Technical Service Bulletin: tsb100162

Released Date: 09-May-2002

LTA and Intercooler Tube O-Ring

Figure 1

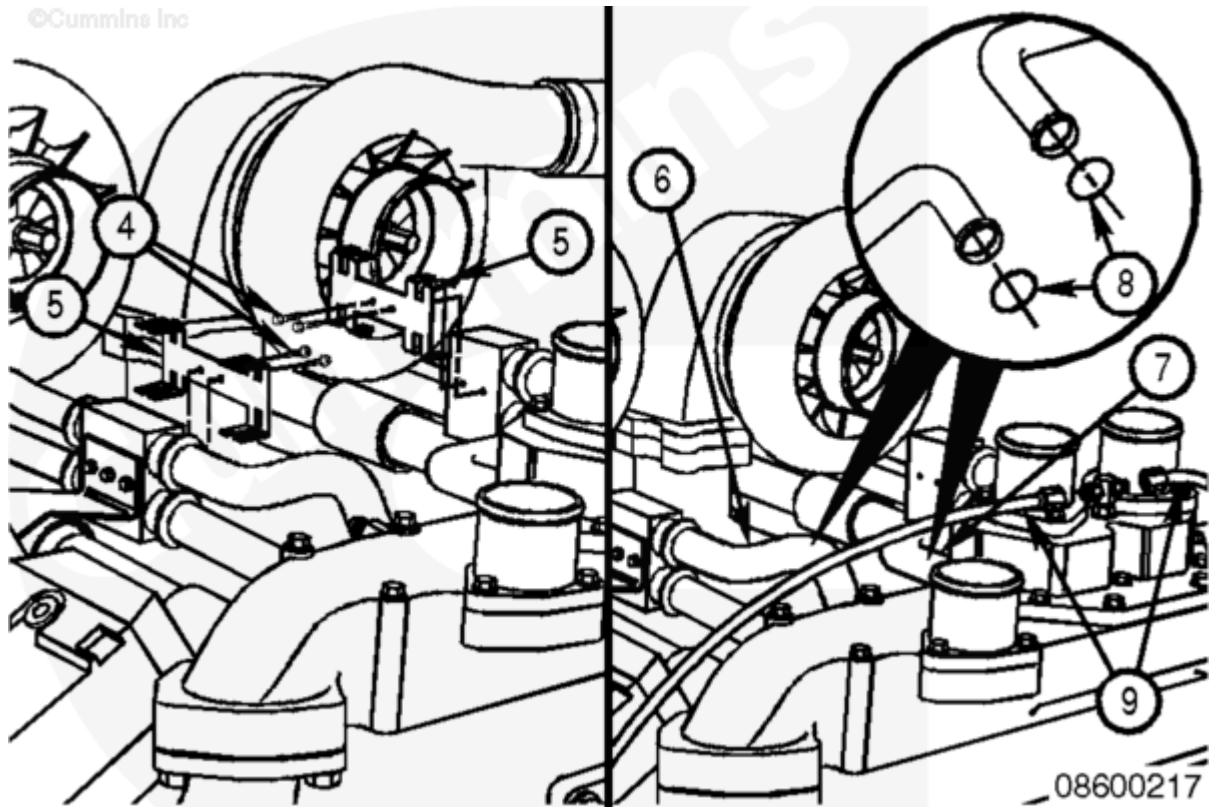
This Technical Service Bulletin is to introduce a new LTA and intercooler tube o-ring, Part Number 4066112, for QSK60 Industrial and Power Generation engines. The new o-ring is a Viton/EPDM blend, which is a material that offers resistance to swell without the long term decomposition associated with the contact with coolant.

This change went into production at the Daventry Engine Plant on 23-Apr-2001. The approximate ESN first is 33149297.

New Part Number	Quantity	Description	Old Part Number	Quantity	Description
4066112	1	Seal, O-Ring	3175545	1	Seal, O-Ring

Do not use petroleum-based oil when installing the new o-ring. The use of petroleum-based oil will cause swelling of the o-ring. Use vegetable oil to lubricate the o-ring.
